Mandalong Southern Extension Project

MOD 10

Submissions Report

December 2021

Attachment 1 – Mine Design Changes Since Original Approval

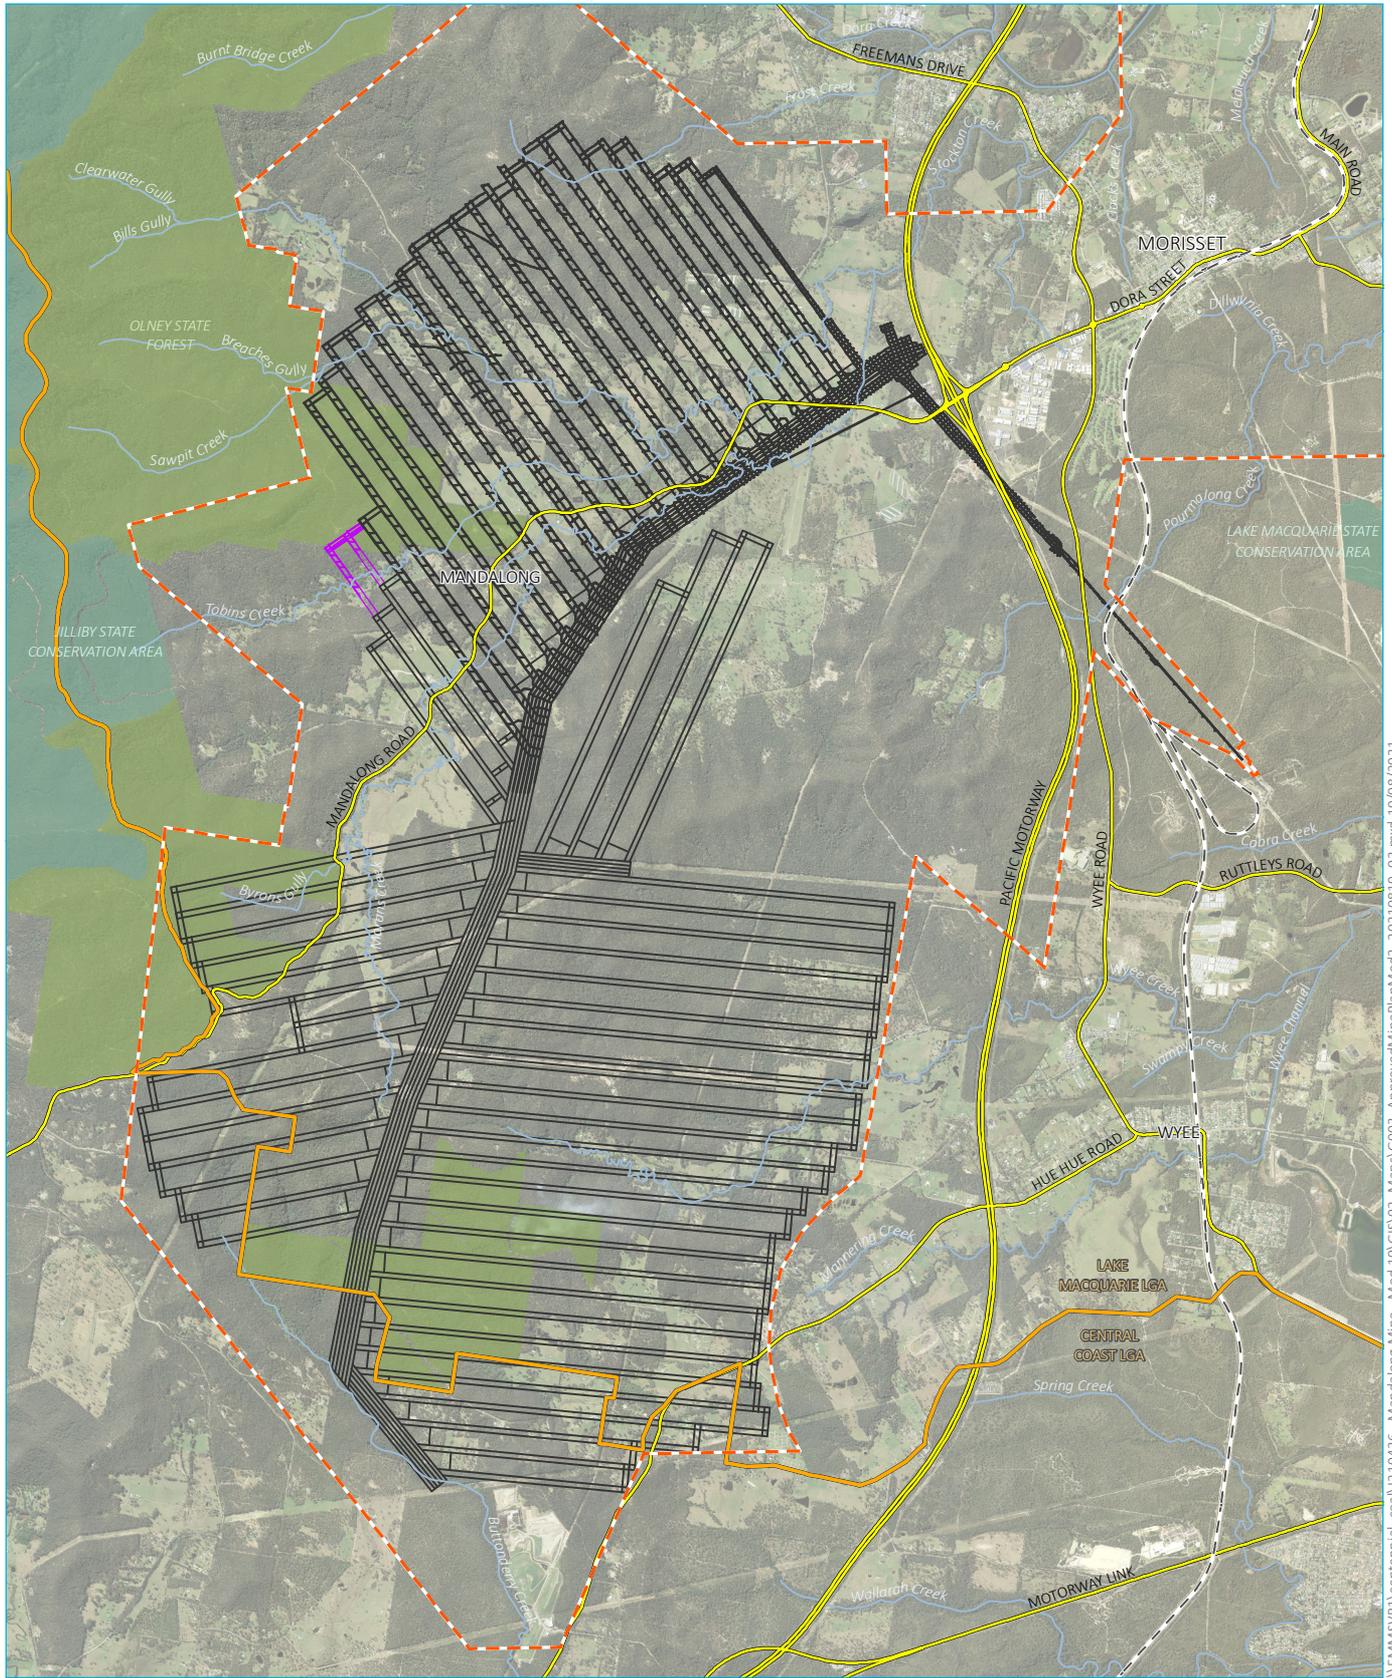
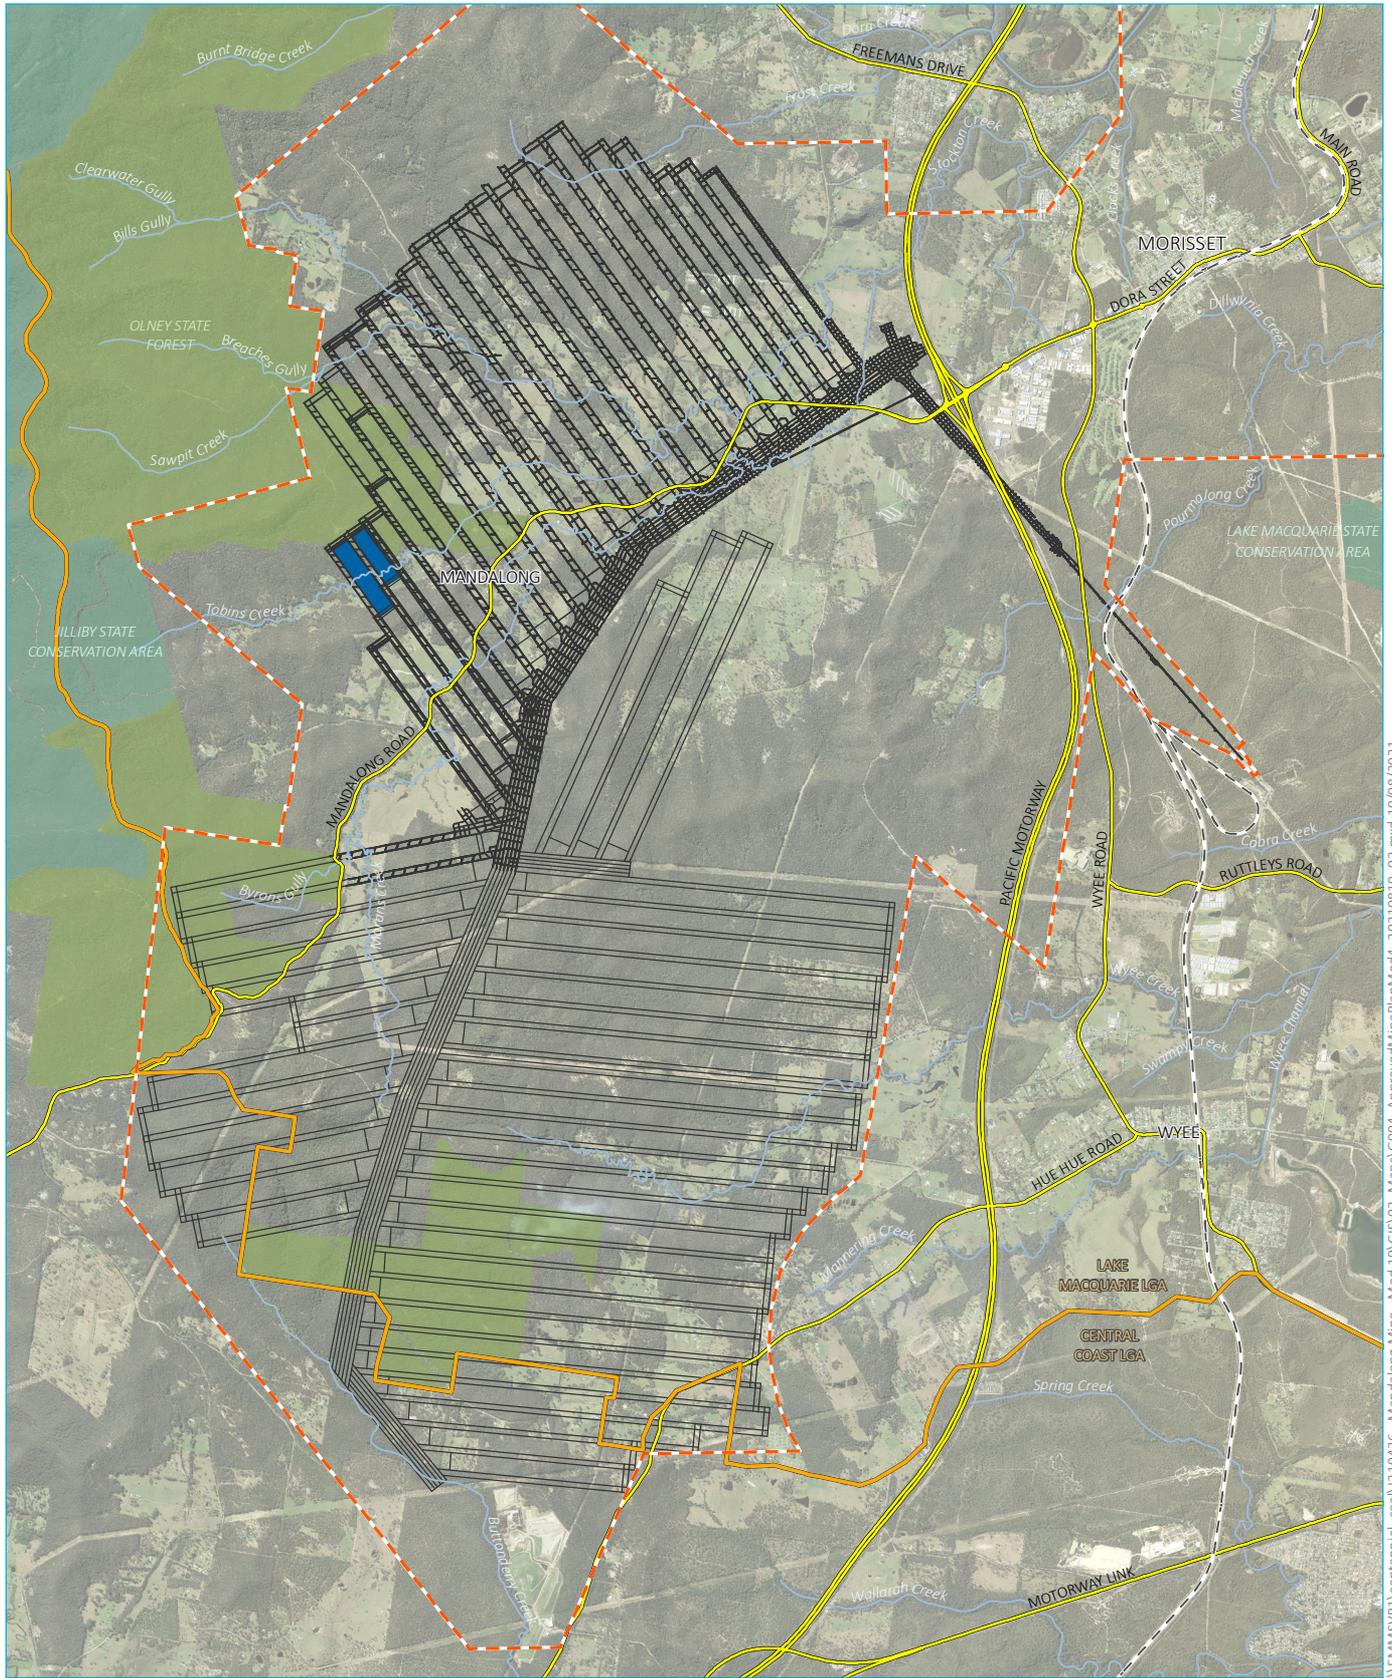
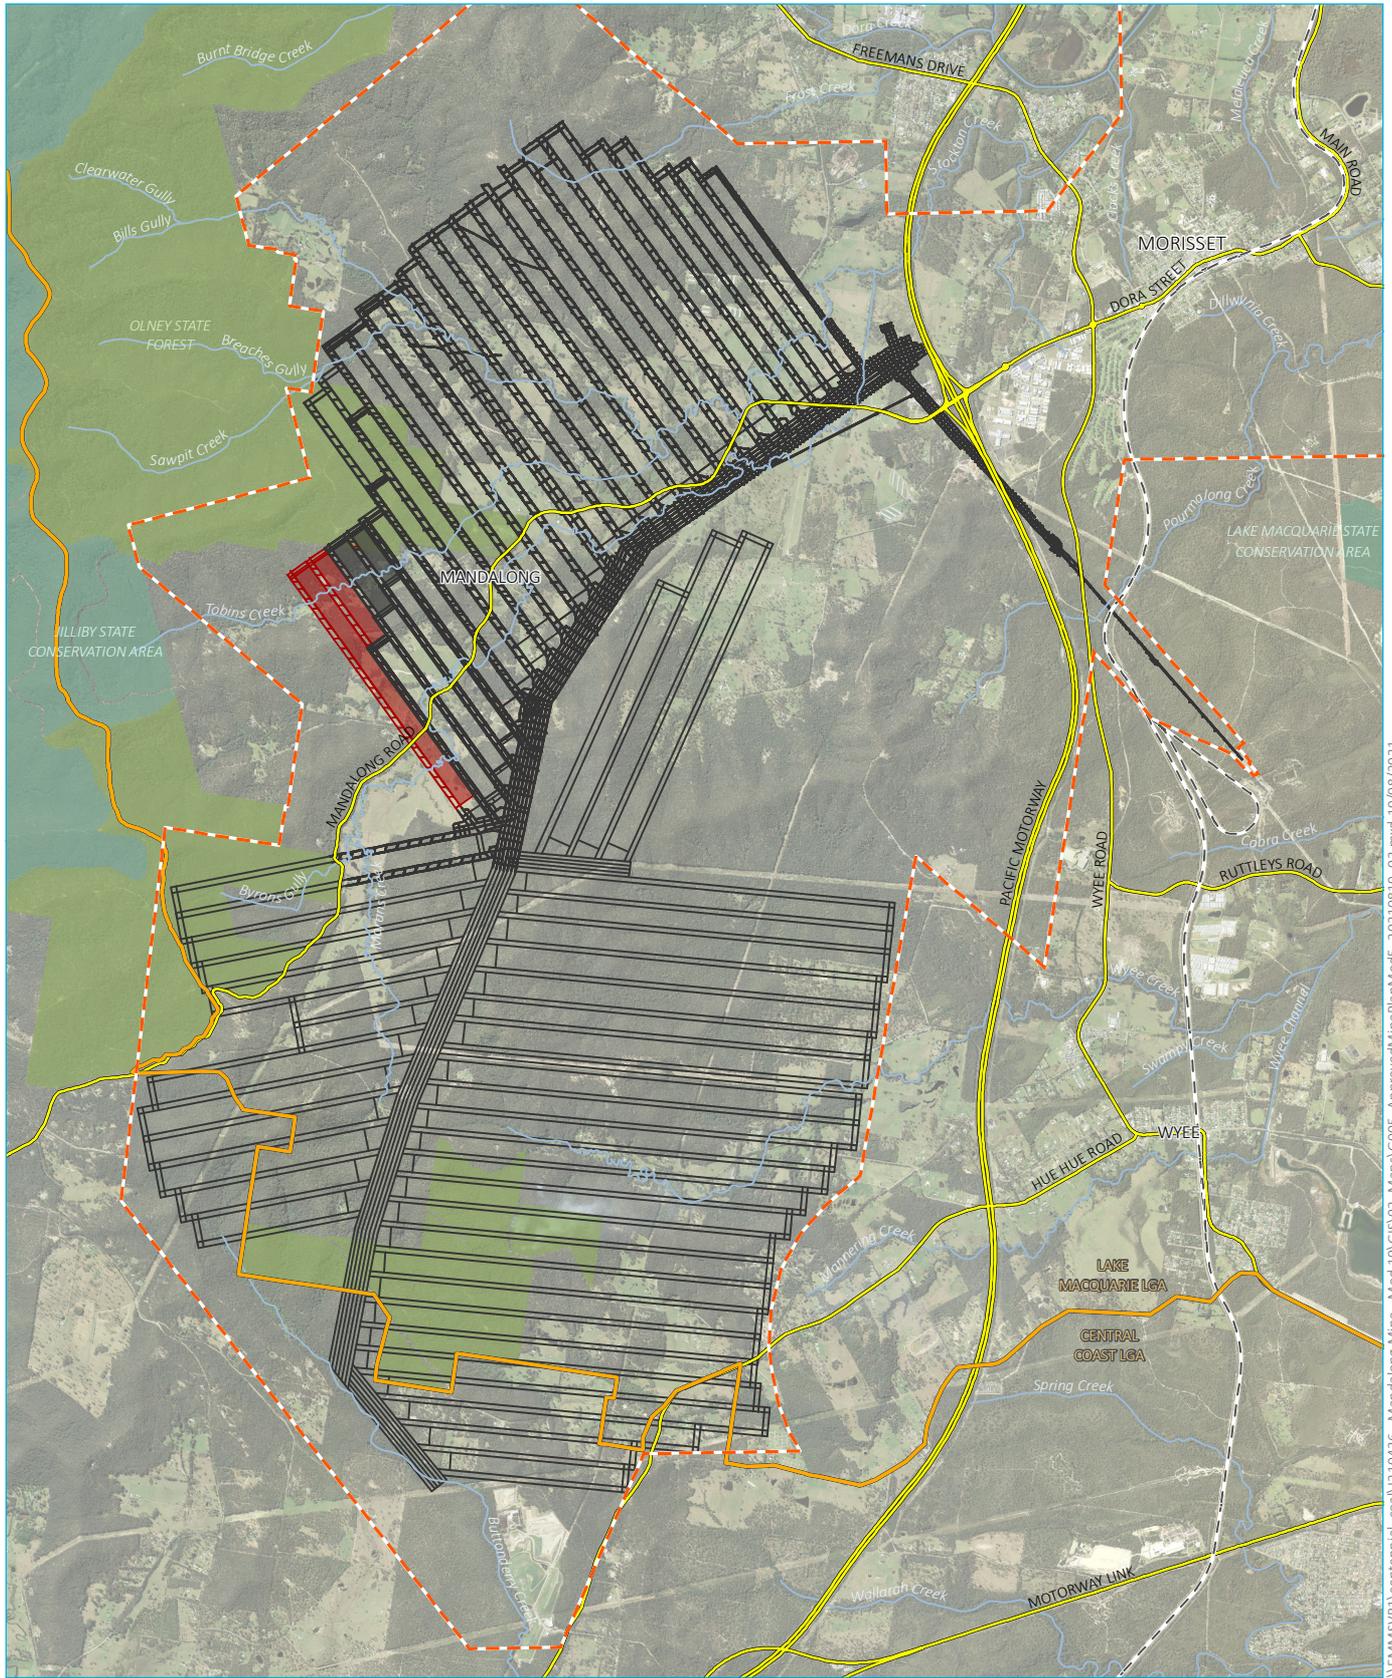
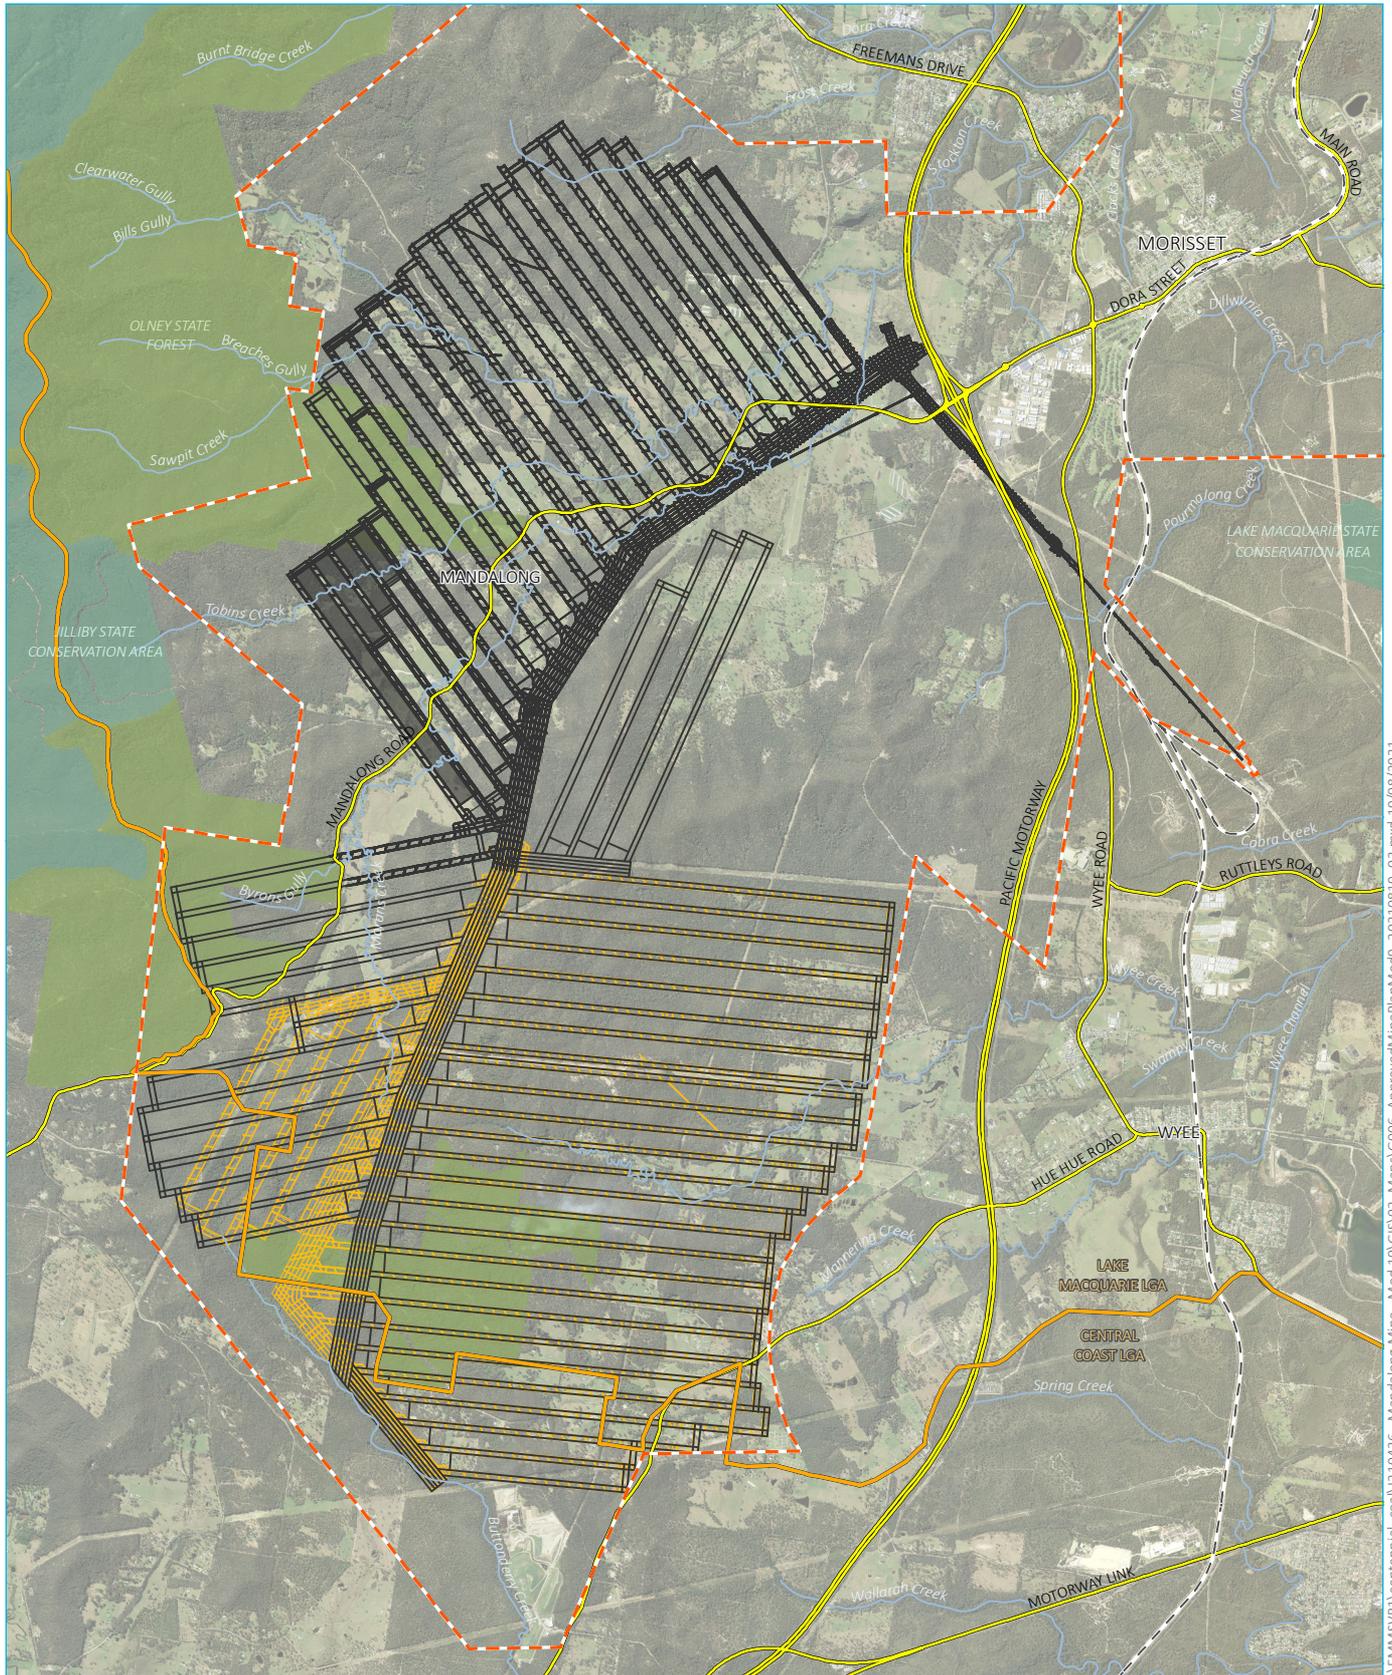
Ten (10) modifications to the Mandalong Southern Extension Project have been pursued since development consent (SSD-5144) was granted in October 2015. Five modifications are associated with changes to the mine design (MOD 2, MOD 4, MOD 5, MOD 9 and MOD 10). The figures provided as **Attachment 1** show the evolution of mine design changes through the modification process. The changes to the mine design have been necessary to adapt to updated geological information not available at the time the EIS was submitted. Centennial Mandalong consider the changes to the mine design, as shown by the figures provided in **Attachment 1**, to be substantially the same development as originally approved.
